Architect's Supplemental Instructions

Architect's ASI No: 024

Project:
Webster University
Interdisciplinary Science
Building

Description: ASI – 024 (RFI-222, 233, 235 & 236)

P0105.A

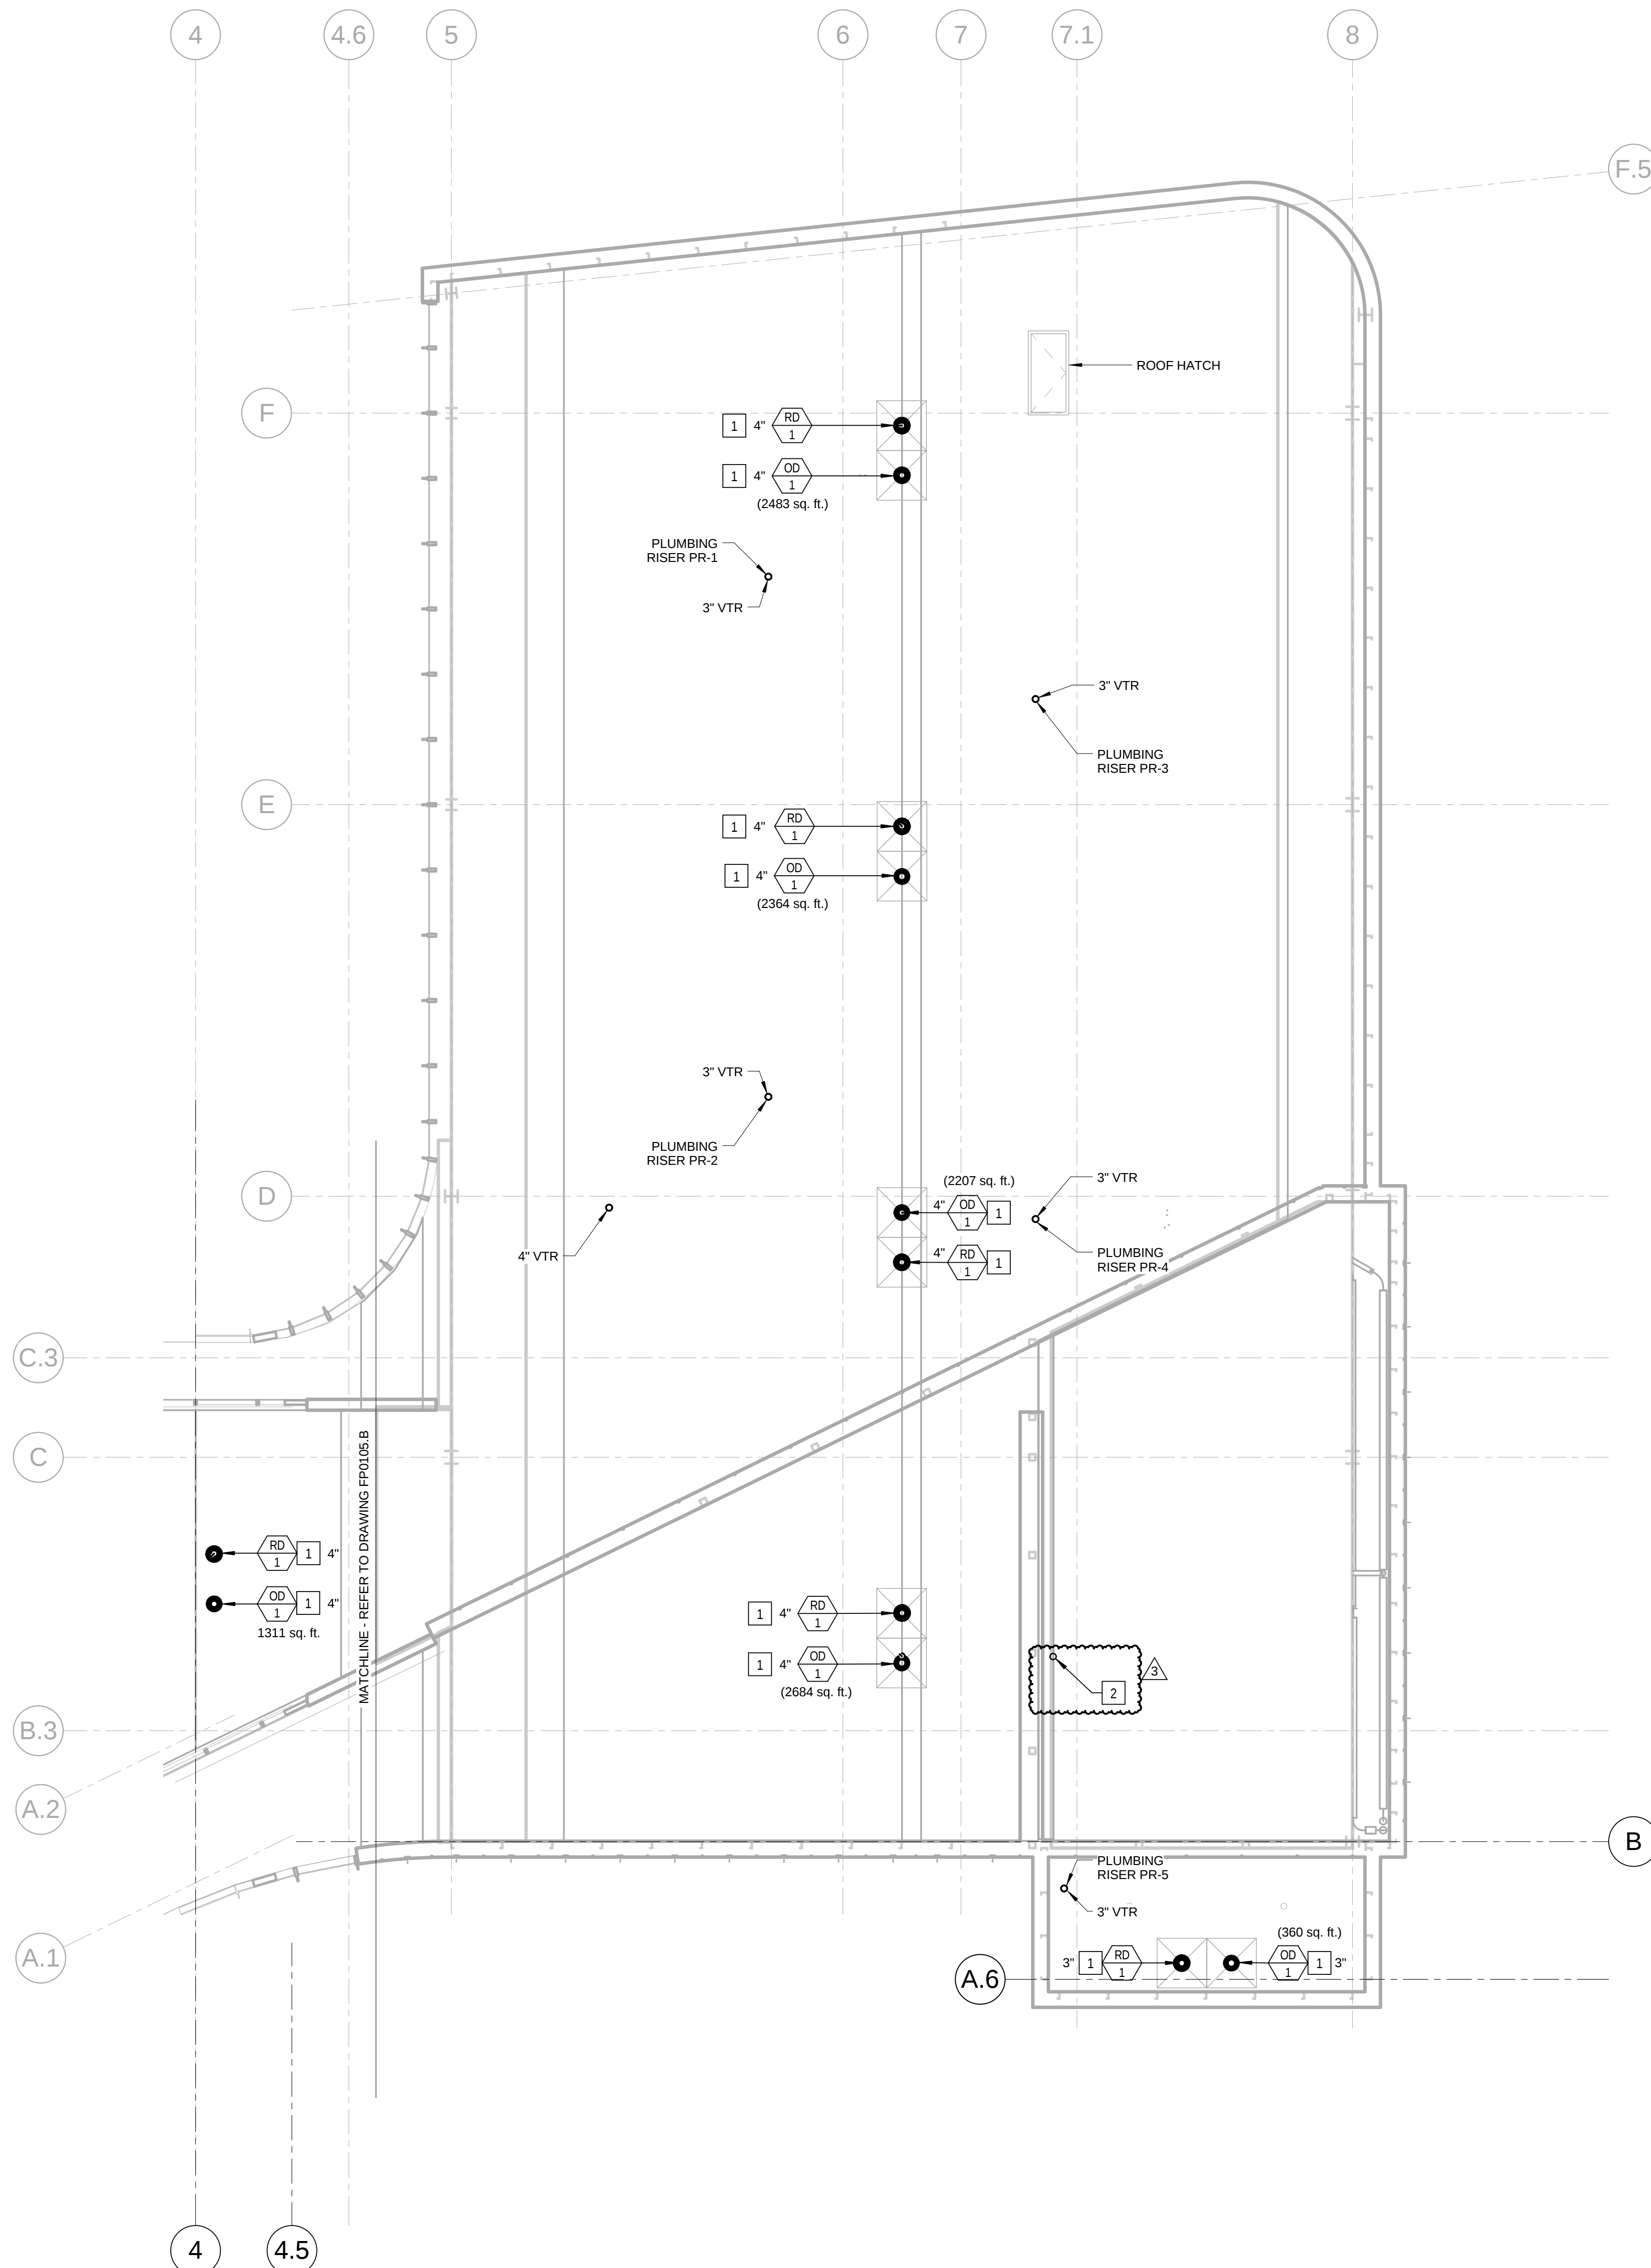
RFI-236, (P0104.A, P0111.A & P0105.A); Provide and install ¾" CW service up through roof to serve Non-Freezing Sanitary Roof Hydrant, Jay R. Smith model 5903 or equal. Refer to sheets P0104.A, P0111.A and P0105.A for all changes. Coordinate exact location of hydrant with Architect prior to rough-in.

P0111.A

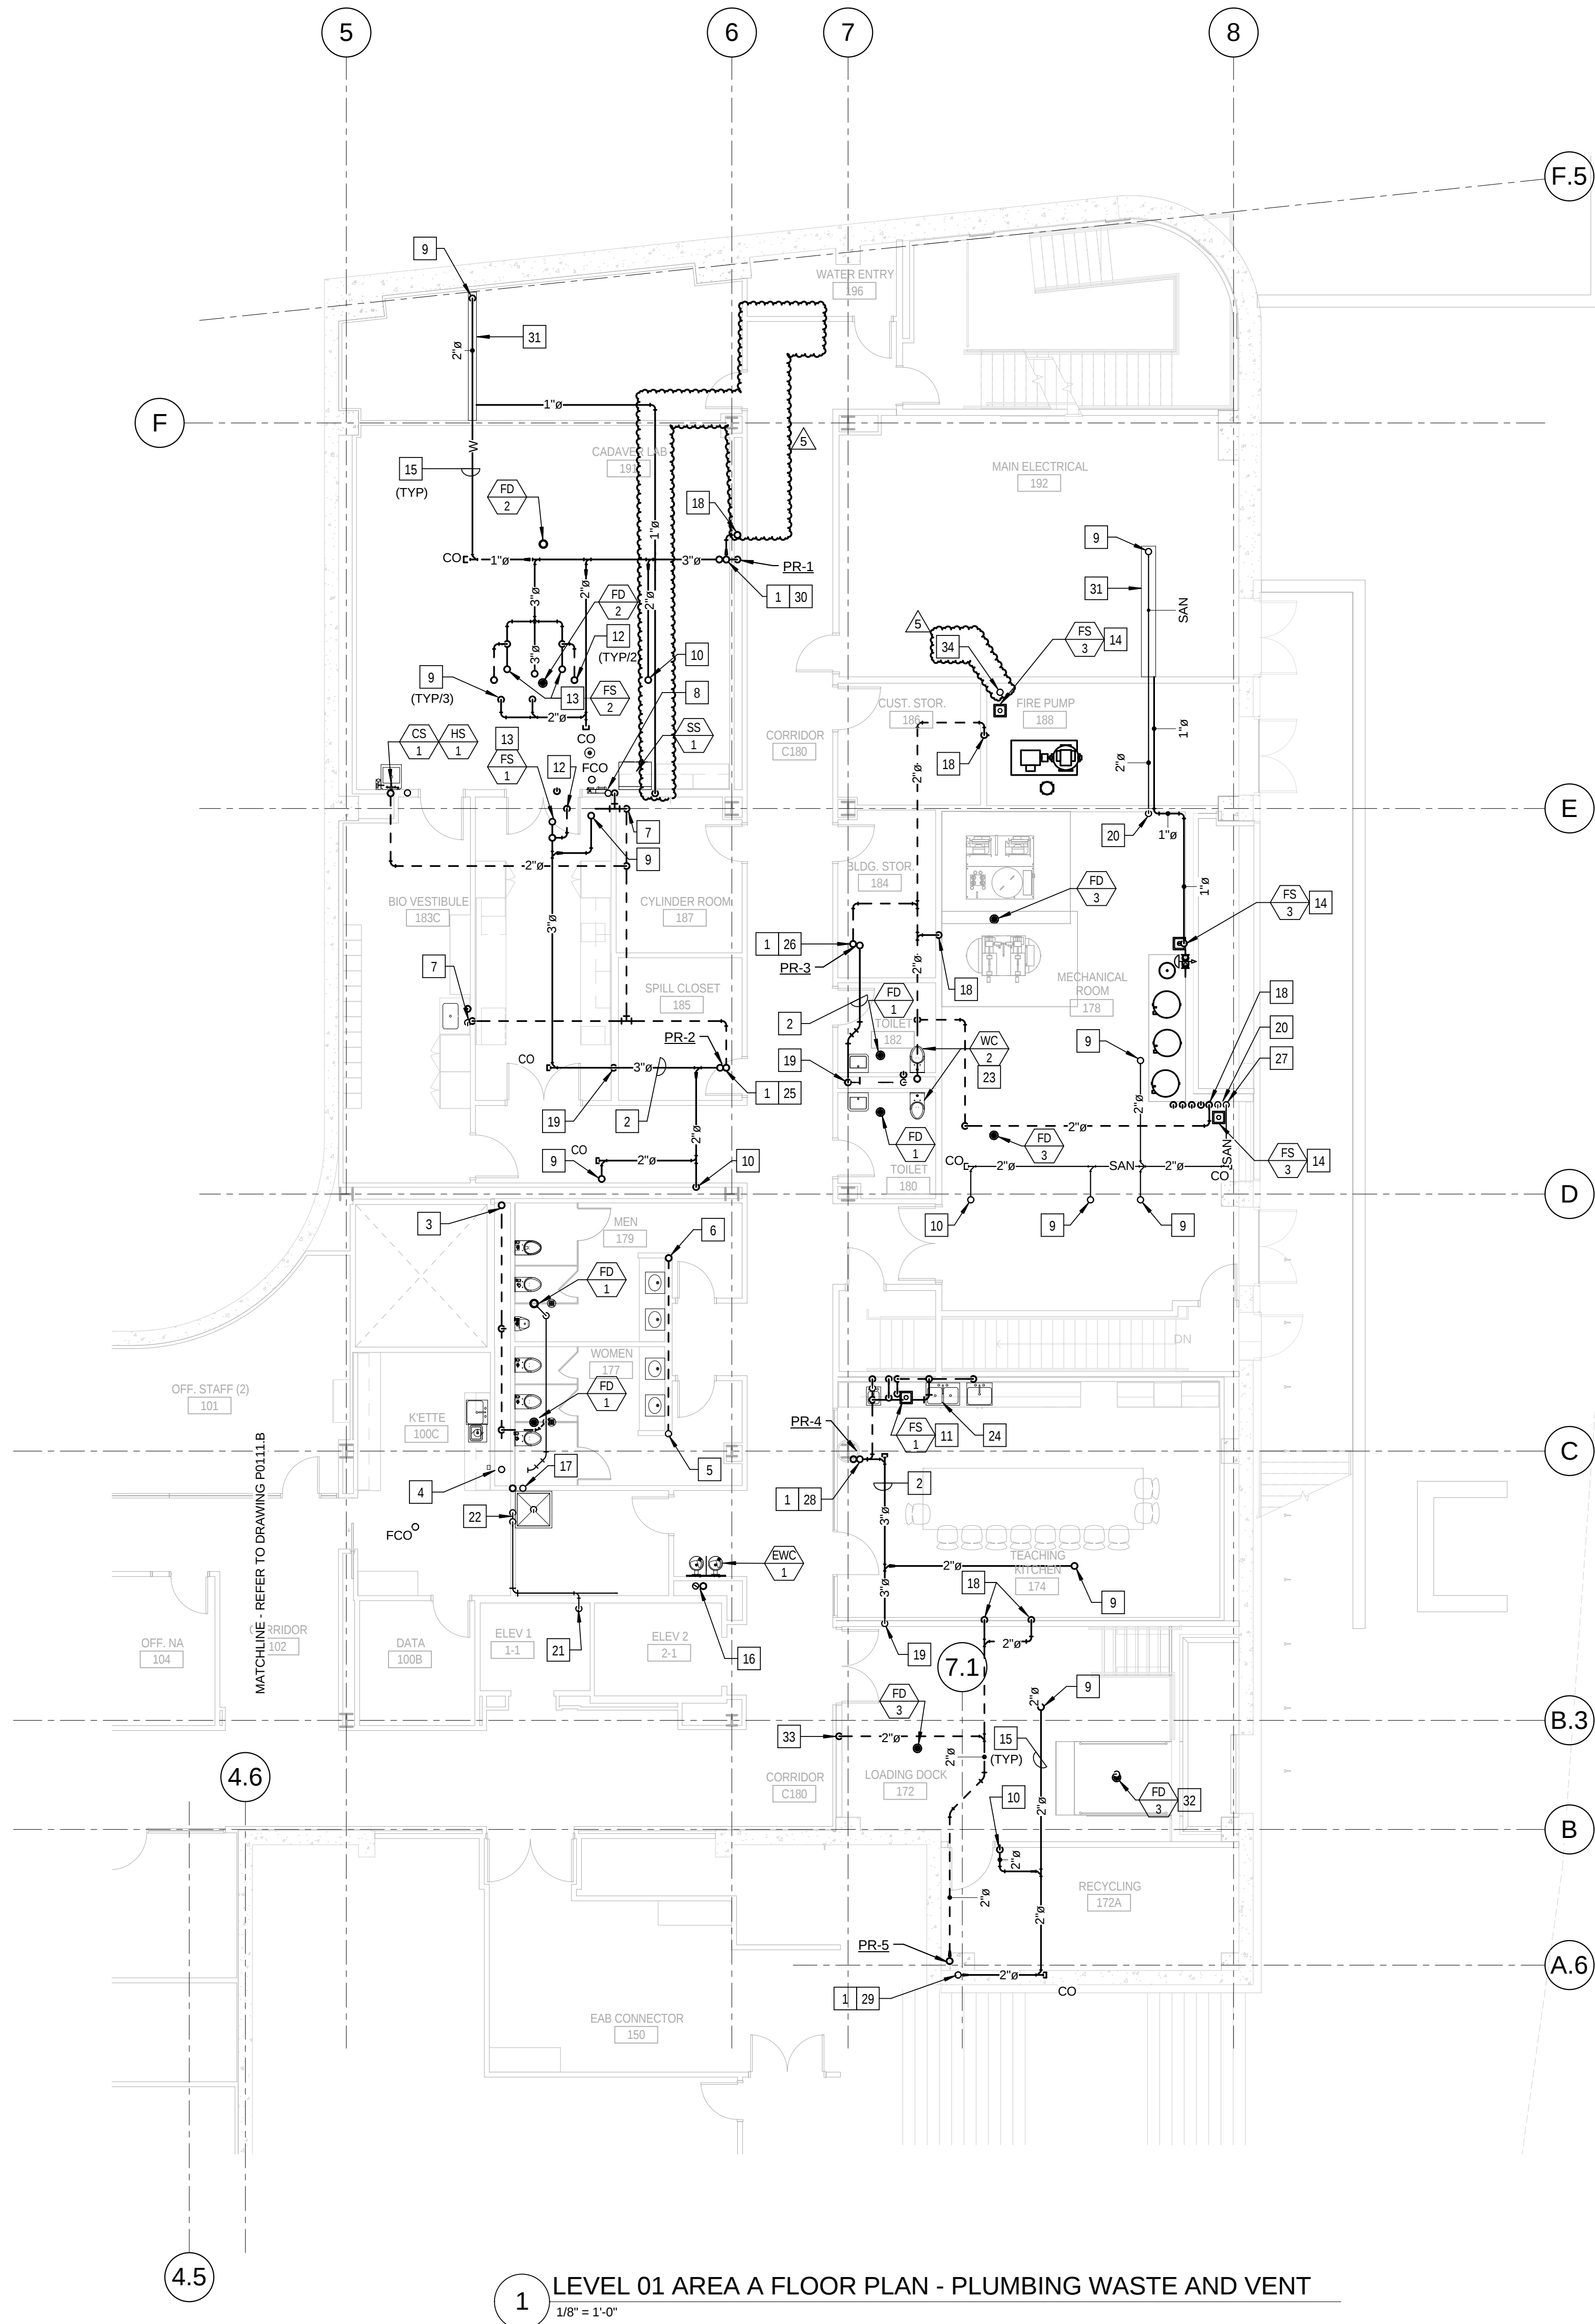
RFI-222, (P0011 & P0111.A); Provide and install 4" CI Standpipe 2 feet above finish floor for sprinkler system drainage. Refer to sheets P0011, P0101.A & P0111.A.

P0111.B

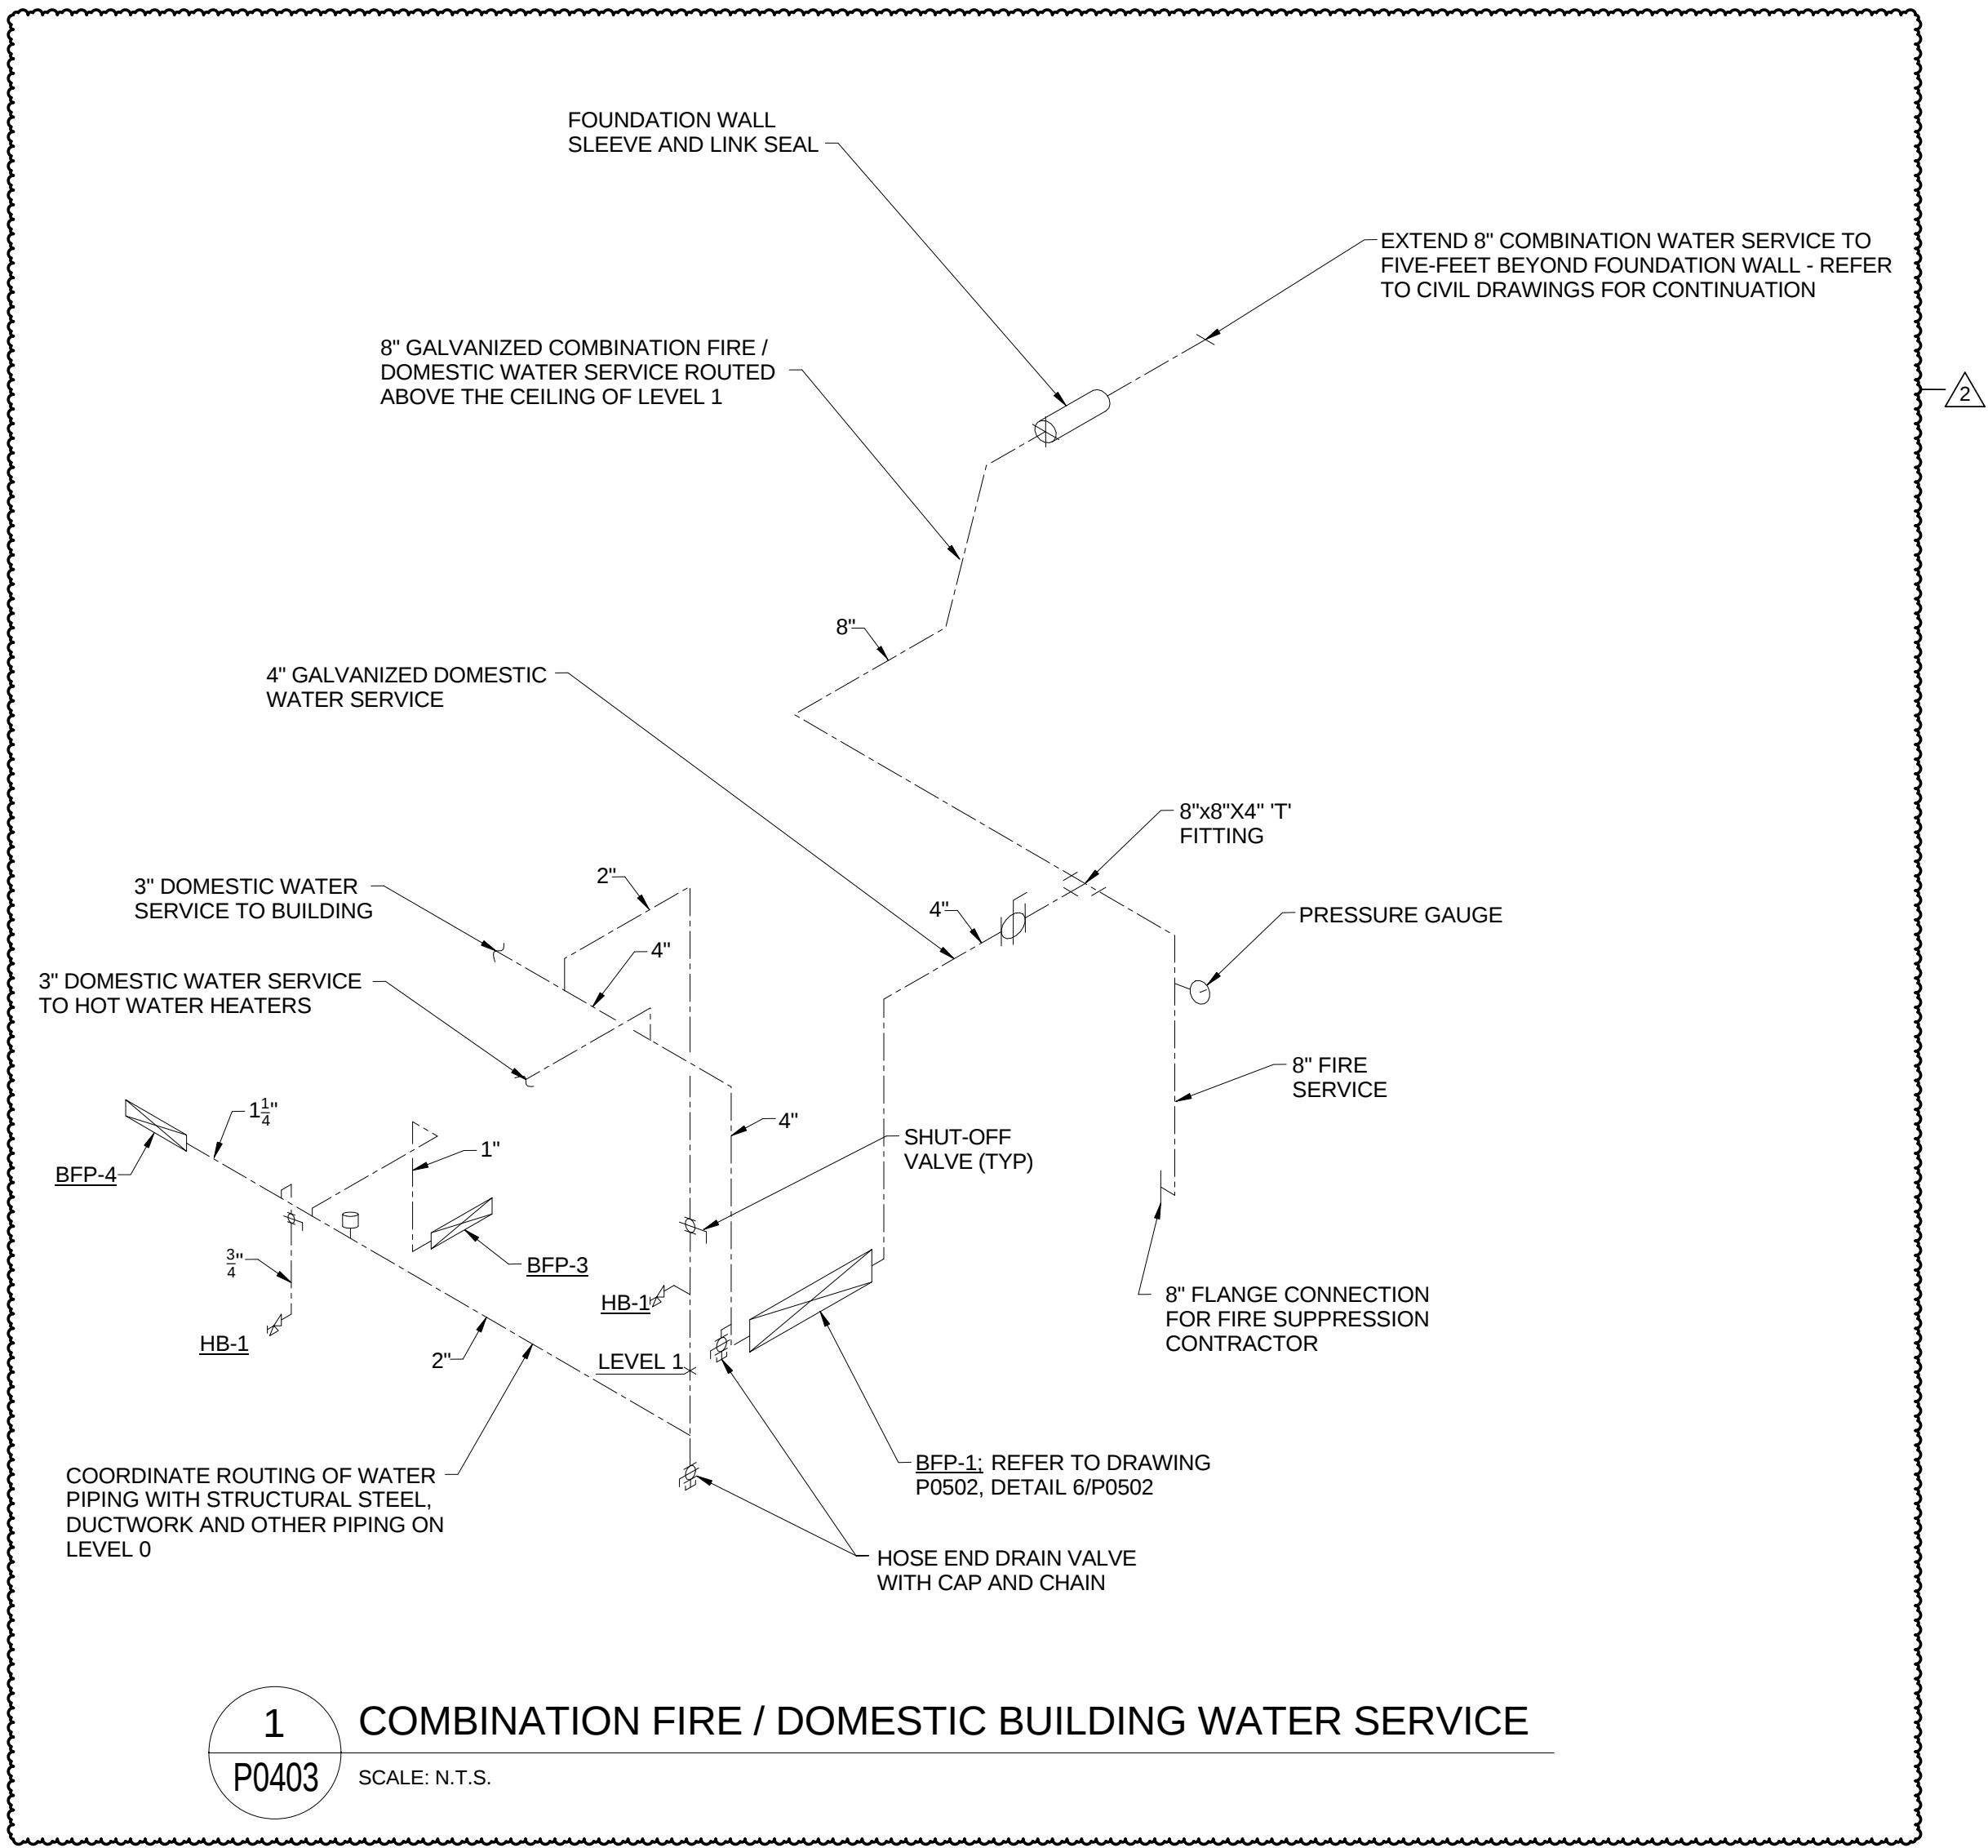
RFI-233, (P0111.B); Re-route 1-inch drip pan drain line as noted on plan sheet P0111.B, to avoid conflict with structural steel members. Drop down in west wall to connect to tailpiece at scrub sink along wall. Refer to sheets P0111.B for all changes.
